ENGINE - FUEL AND CONTROL - DEDICATED ALTERNATOR STATOR - INTRODUCTION OF NEW SOURCE OF
SUPPLY - CATEGORY CODE 7 - MOD.ENG-73-0076

V2500-ENG-73-0076

LOCATION OF DEDICATED ALTERNATOR STATOR
Fig.1

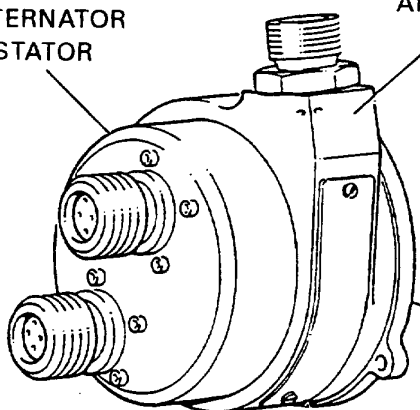
A1 ENGINE
REMOVE 1664 Mk 4
AND INSTALL 430110
AT LOCATION A

A5 ENGINE
REMOVE 1774 Mk 1
AND INSTALL 430110
AT LOCATION A

- (1) Install the new 430116 Air Shroud to the 430110 Dedicated Alternator Stator by inserting shroud dowel into hole position 2 of the stator, install assembly as instructed in the A320/A321 Engine Manual, TASK 72-00-60-450-001-A00 or TASK 72-00-60-450-B00.
